ROUTE 9A - WEST STREET PROMENADE PROJECT  
 RECONSTRUCTION OF RT. 9A-WEST ST. (BATTERY PLACE TO CHAMBERS ST.)  
 MANHATTAN, NEW YORK COUNTY

FIELD CHANGE SHEETS (JUNE 6, 2012)

BATTERY PARK UNDERPASS APPROACH WALLS MODIFICATIONS

1 TUNNEL PORTAL WALL ELEVATION AT OUTSIDE RAMP

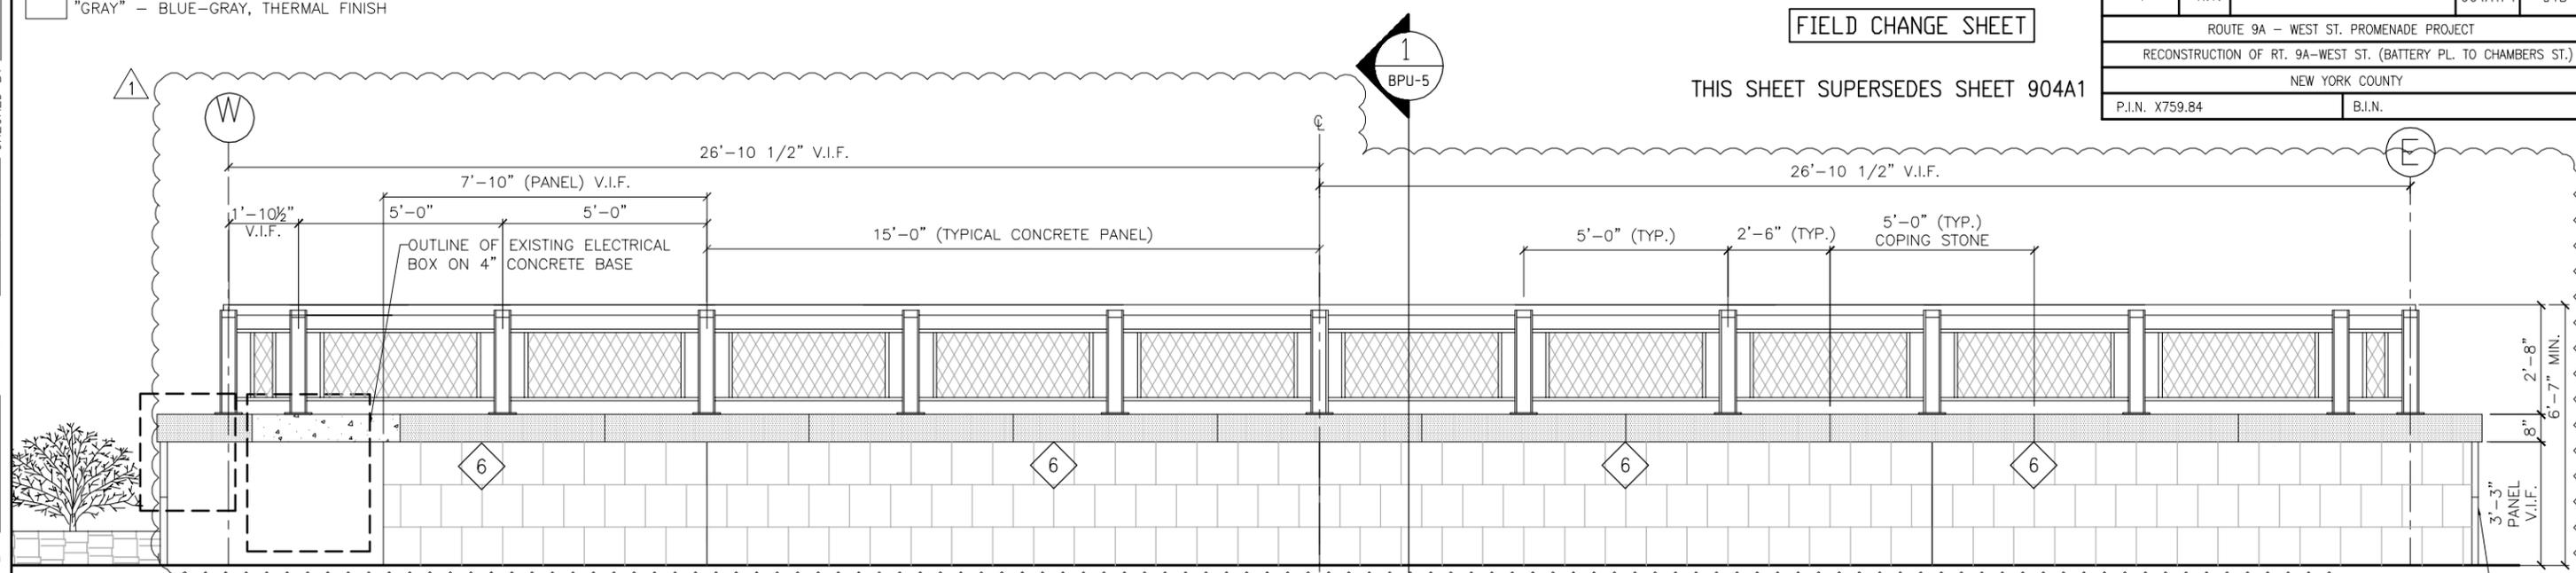
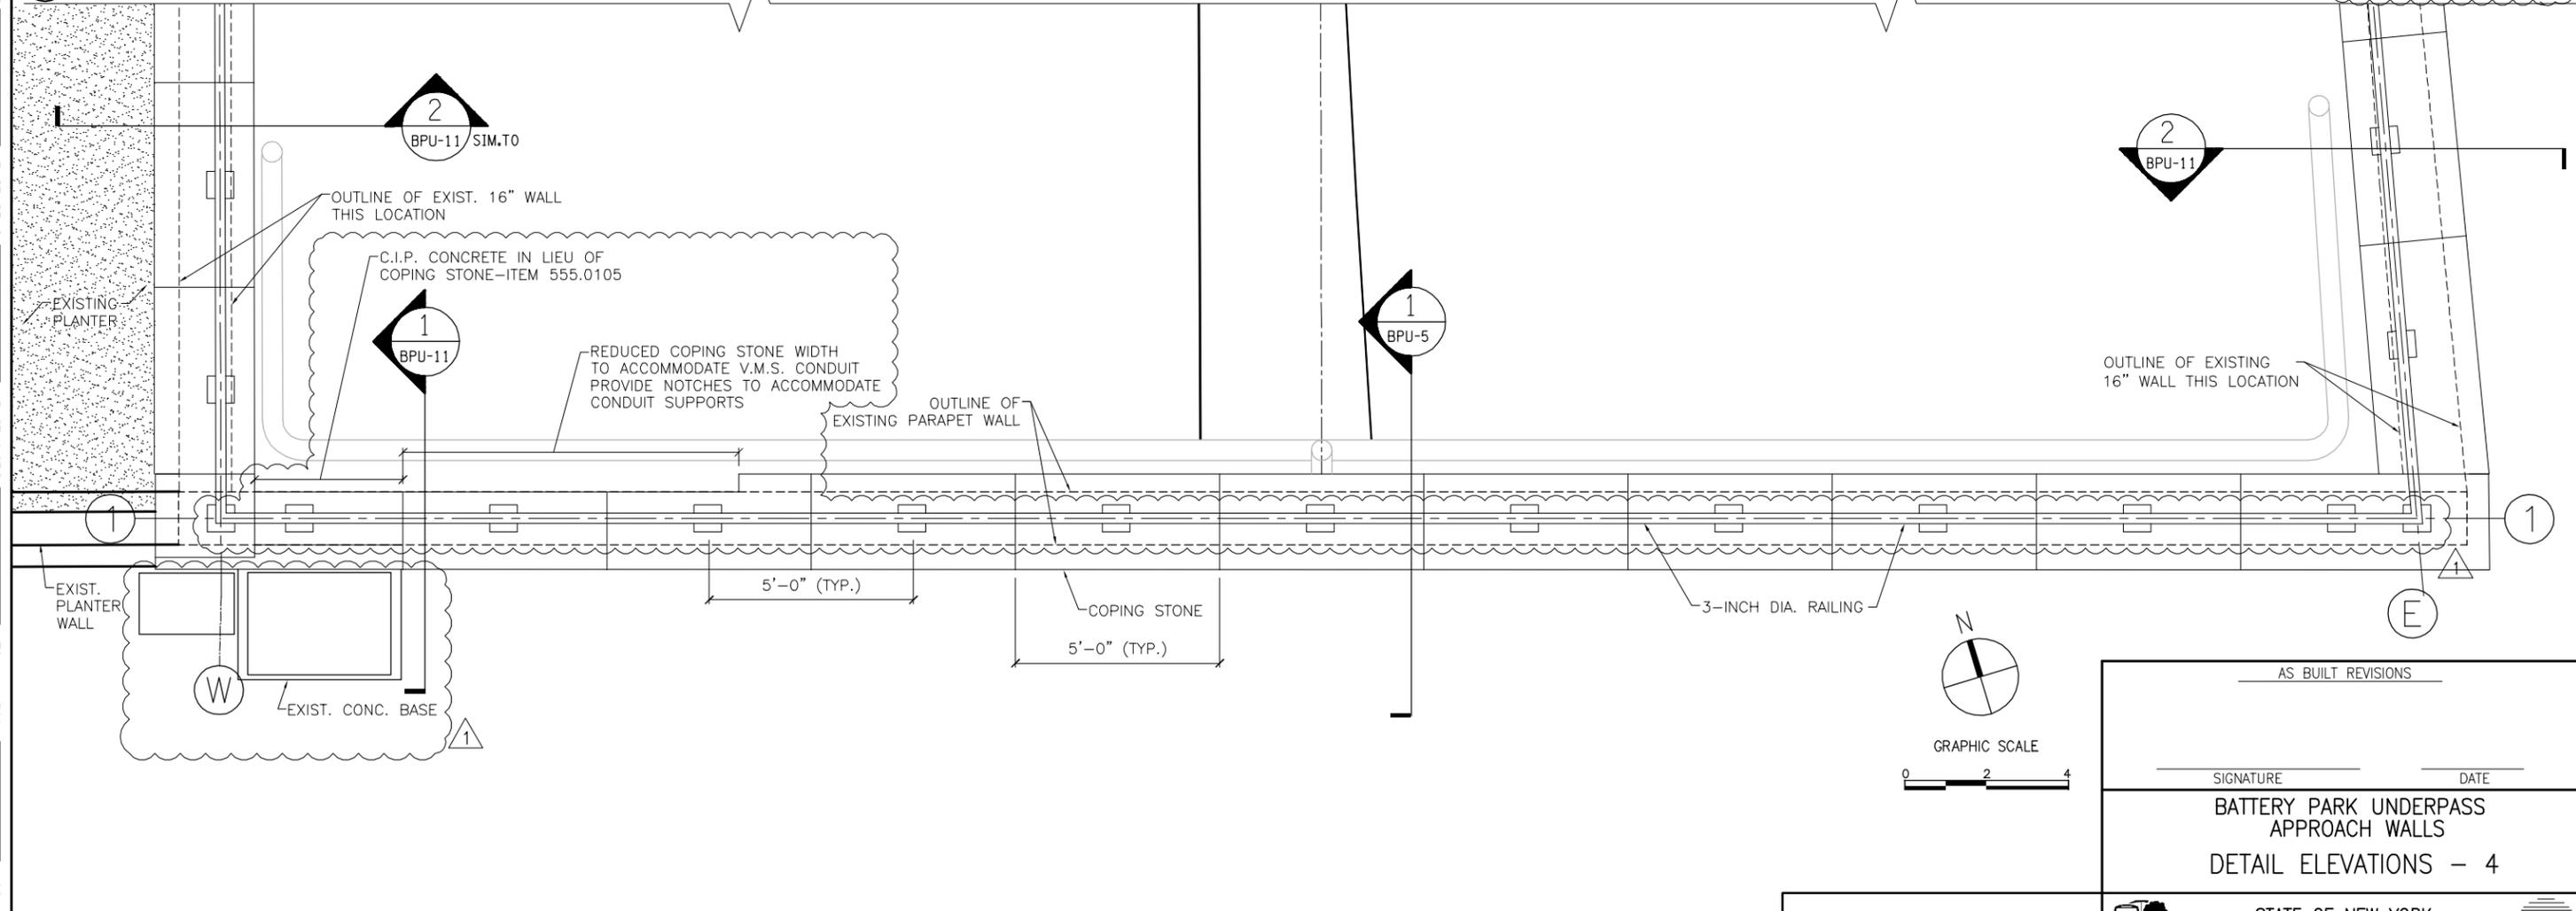
NO.	DESCRIPTIONS REVISIONS	DATE
1	CHANGED PARTIAL ELEVATION-REMOVED BASE FILLER STONES, ADDED NOTE	05/08/2012

1 TYPICAL STONE VENEER PANEL ELEVATION (ITEM NO. 40560.3112)

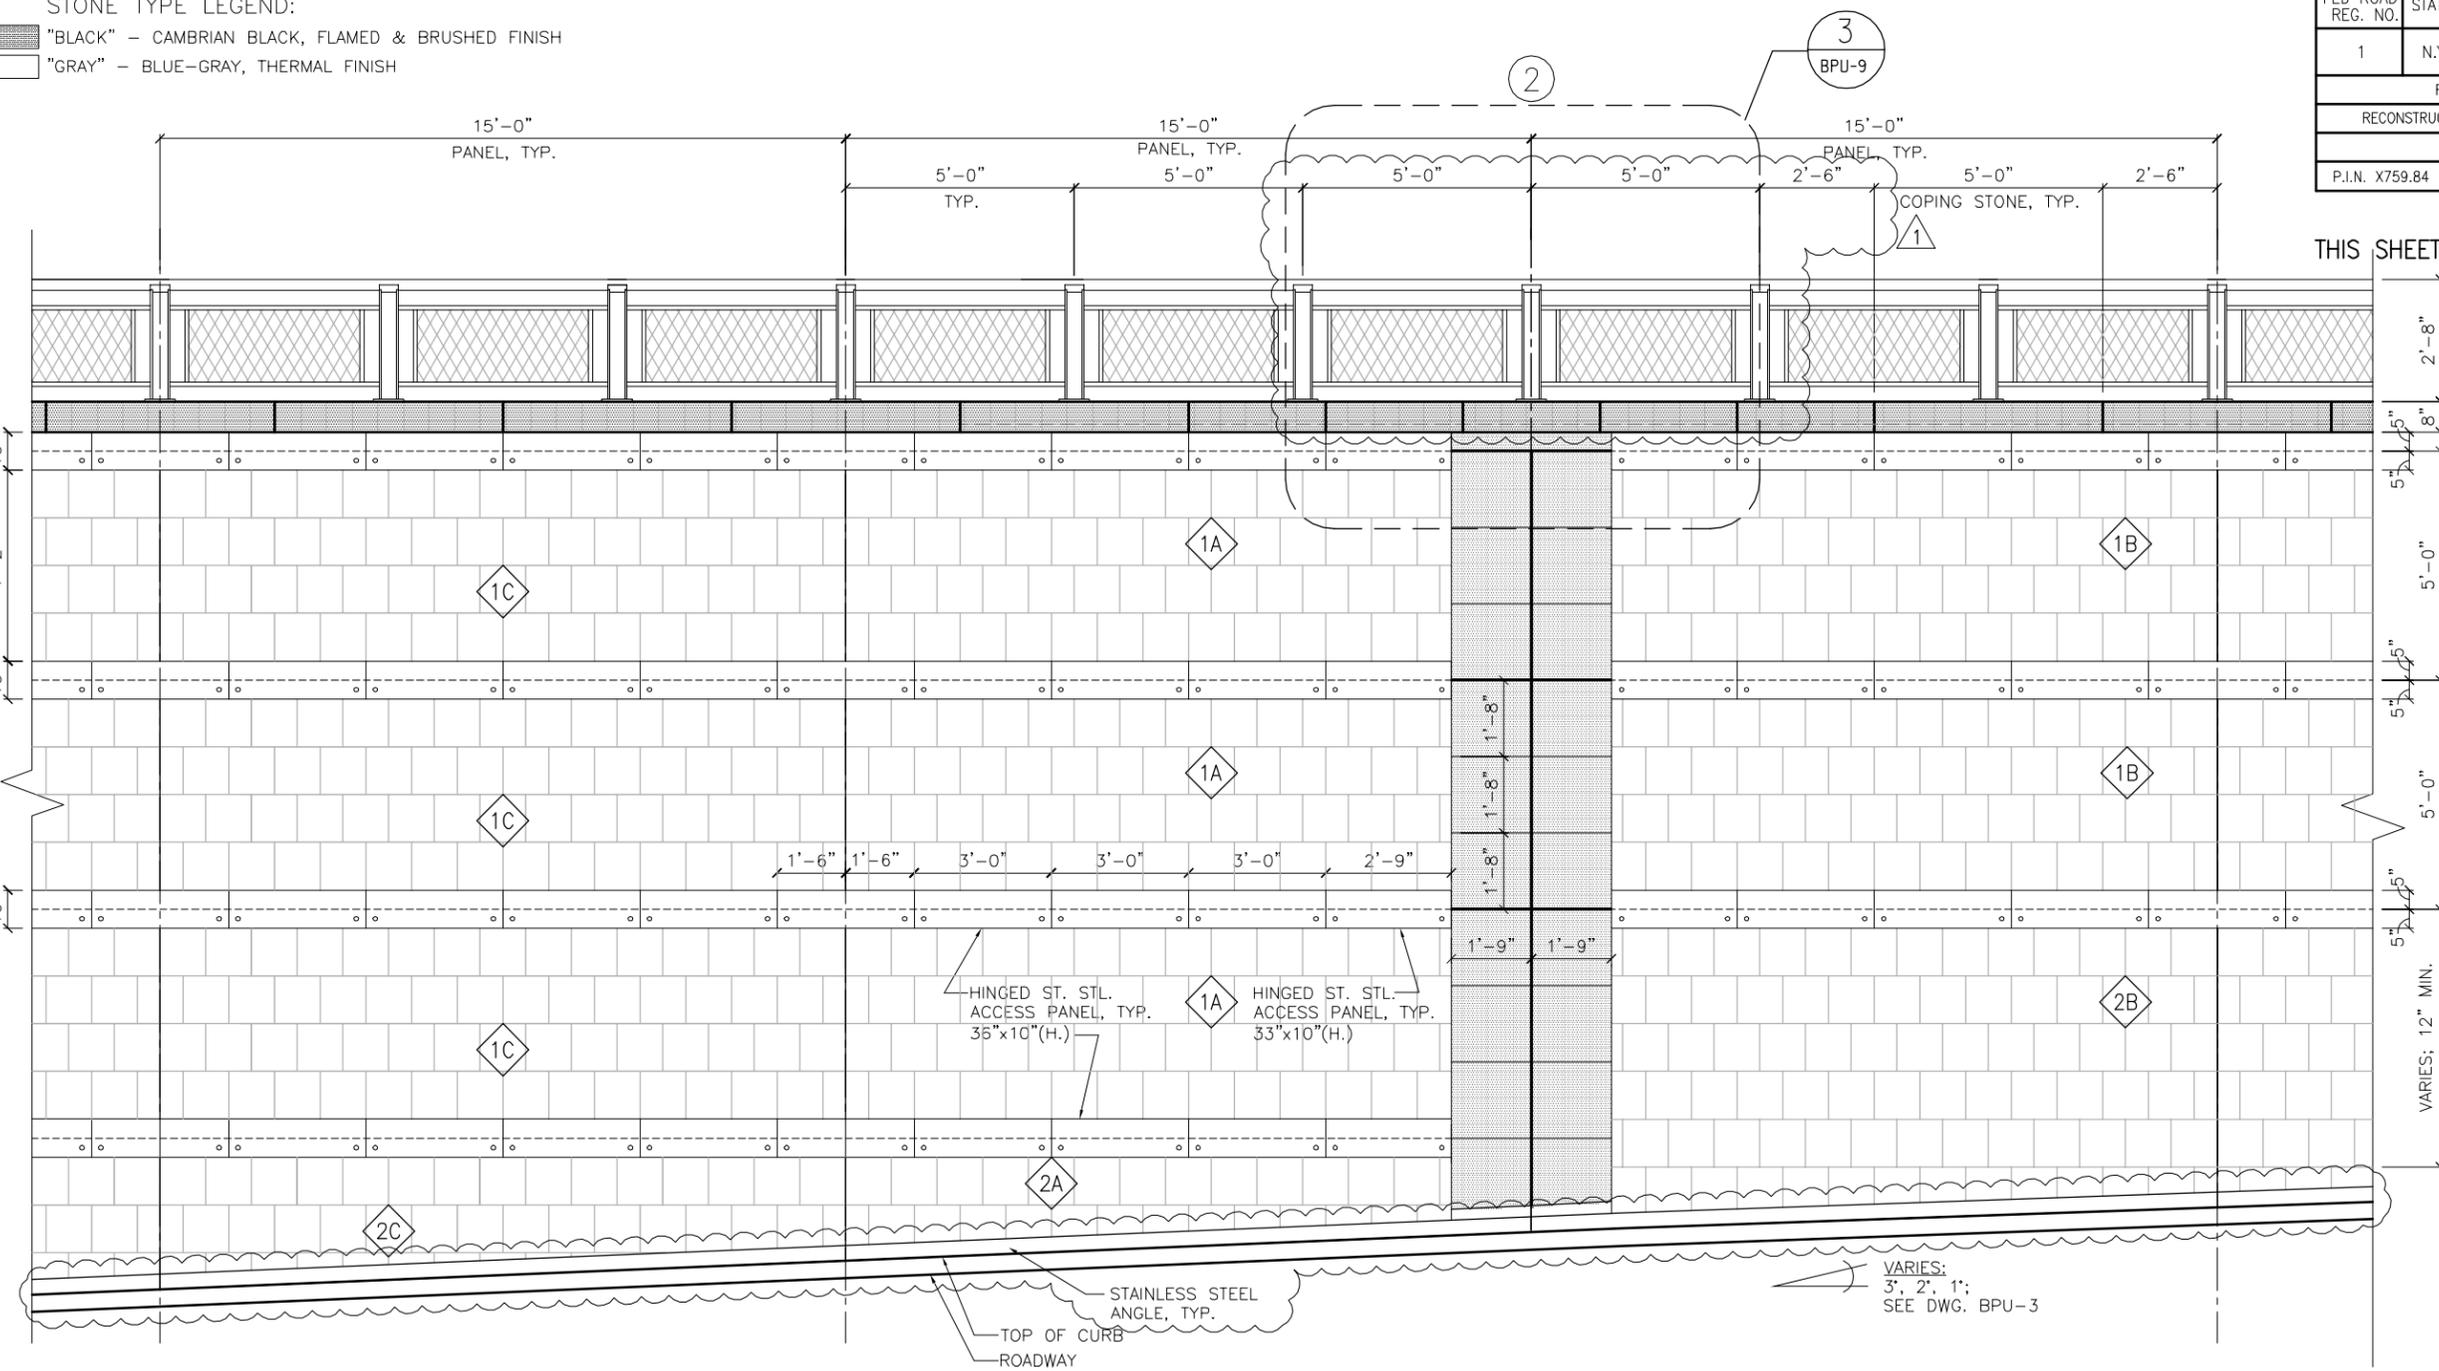
NO.	DESCRIPTIONS	DATE
1	CHANGED TO S.S. ANGLE, DELETED PILASTER HEADS	05/08/2012

- NOTES:
- EXISTING CONDUITS TO BE RELOCATED TO ALLOW INSTALLATION OF PANELS.
  - SEE DWG BPU-14 FOR TYPES OF STONE VENEER PANELS.
  - PRECAST PANELS, PILASTERS STEMS, COPING STONES, AND C.I.P. STONE PAID FOR UNDER ITEM 40560.3112. PILASTER CAPS TO BE PAID FOR UNDER ITEM 40560.36.
  - HINGED STAINLESS STEEL PANELS PAID FOR UNDER ITEM 40656.01

BATTERY PARK UNDERPASS  
 APPROACH WALLS  
 DETAILS & SECTIONS - 1

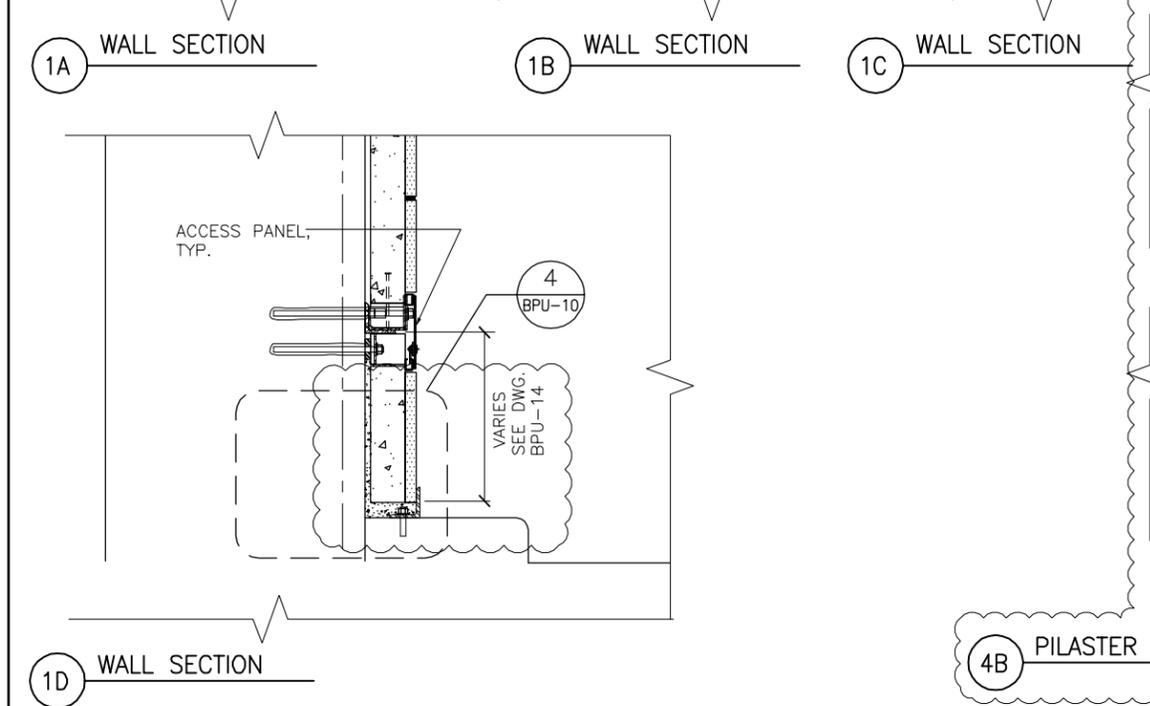
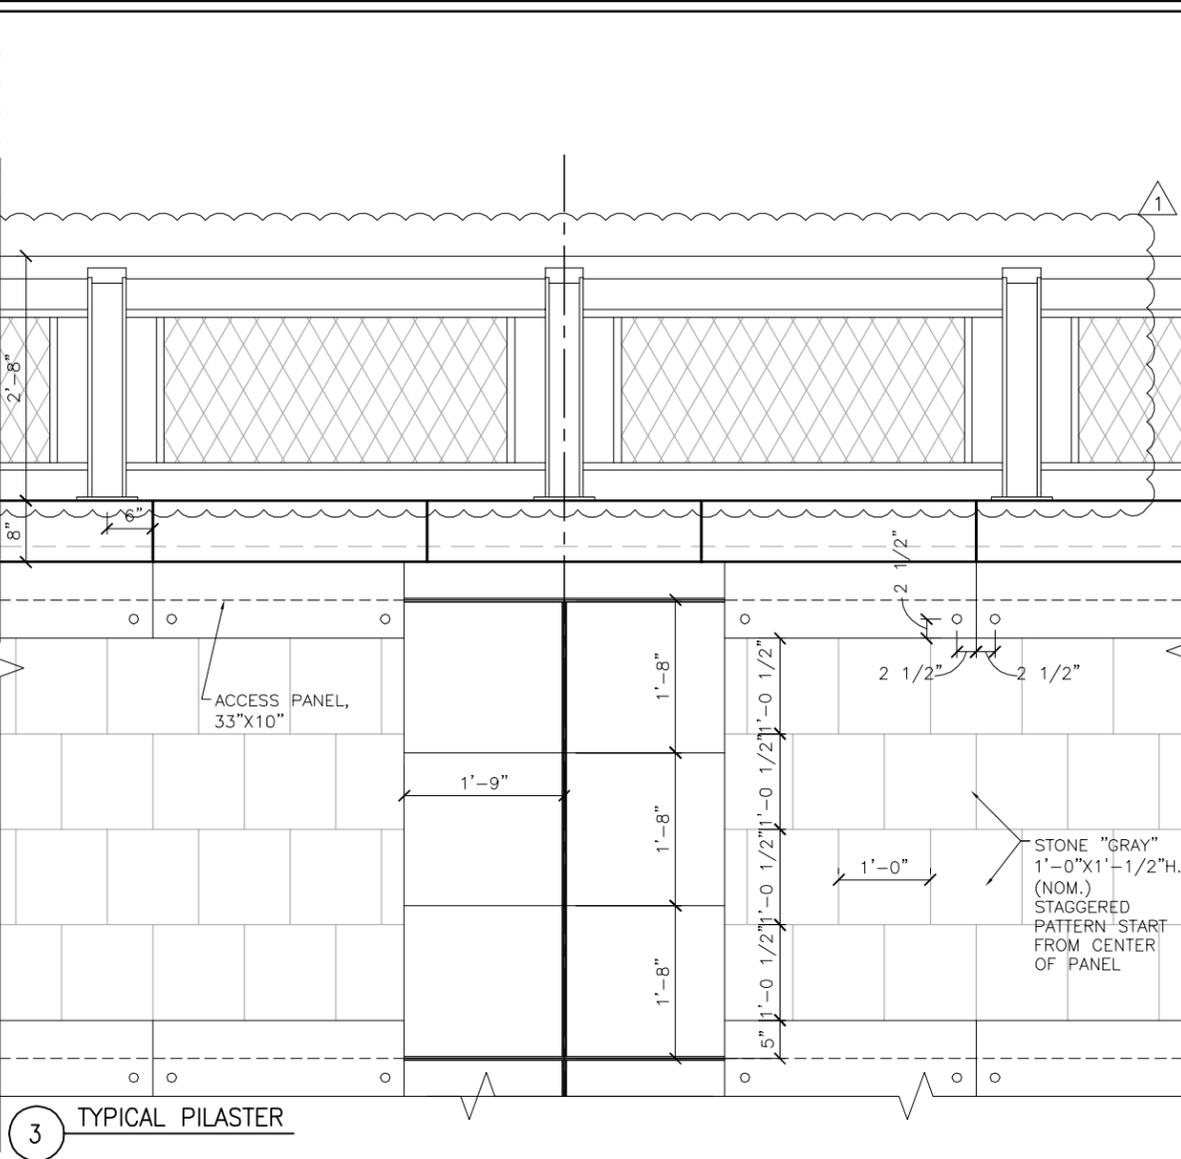
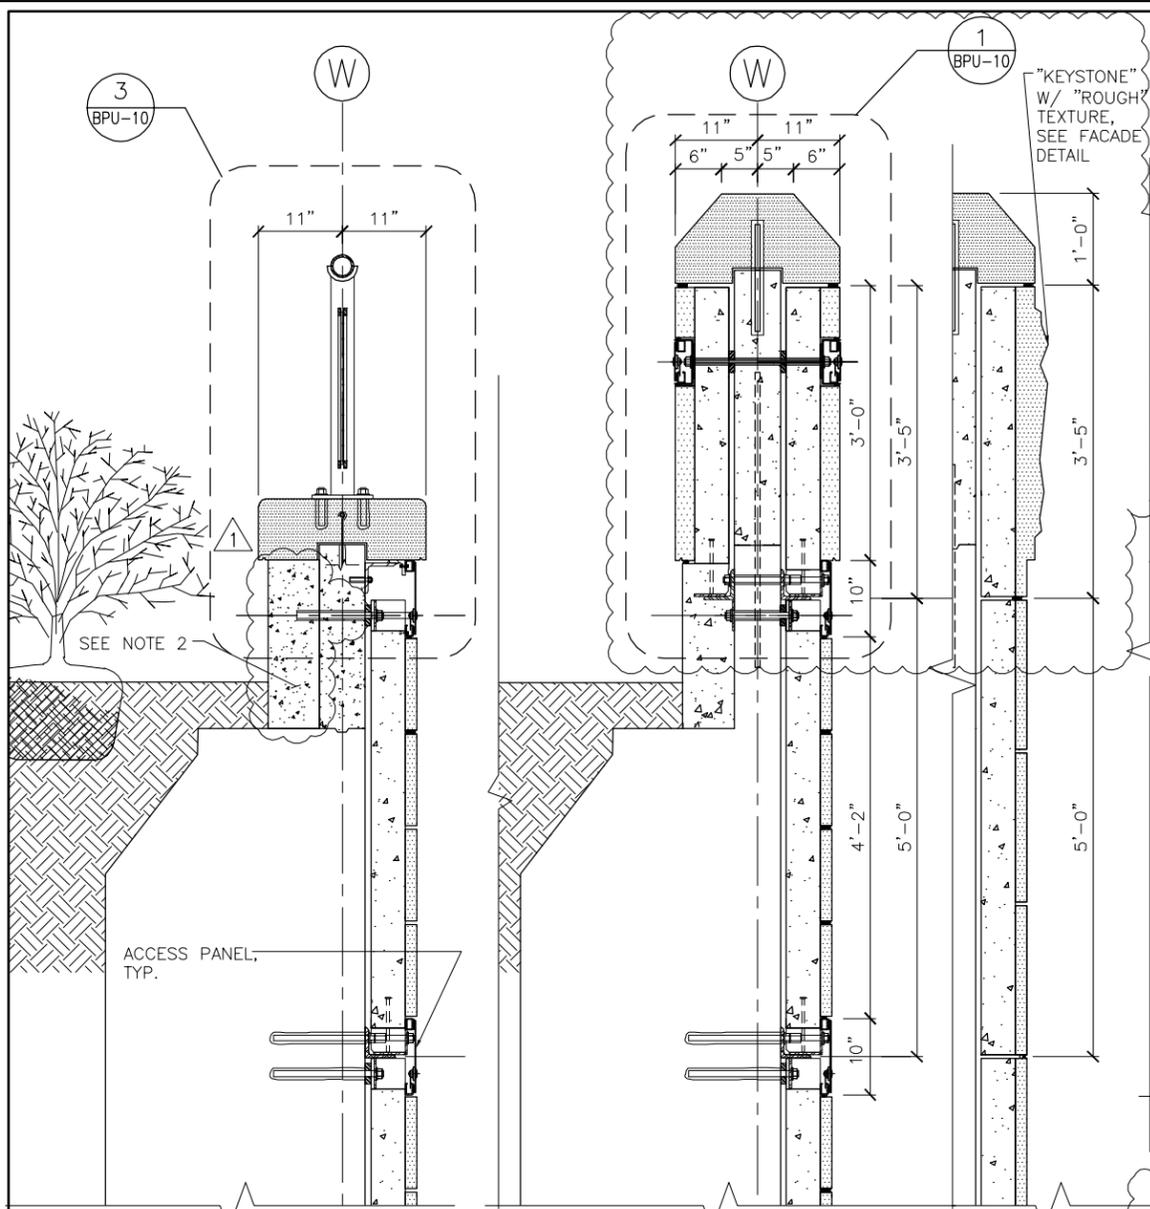
NO.	DESCRIPTIONS	DATE
1	REVISED NOTE, CHANGED TO C.I.P. CONCRETE	05/08/2012

NOTE:  
 1. ALL DIMS ARE NOMINAL TO  $\phi$  OF JOINTS  
 2. C.I.P. CONC. PAID FOR UNDER ITEM NO. 40555.7294.
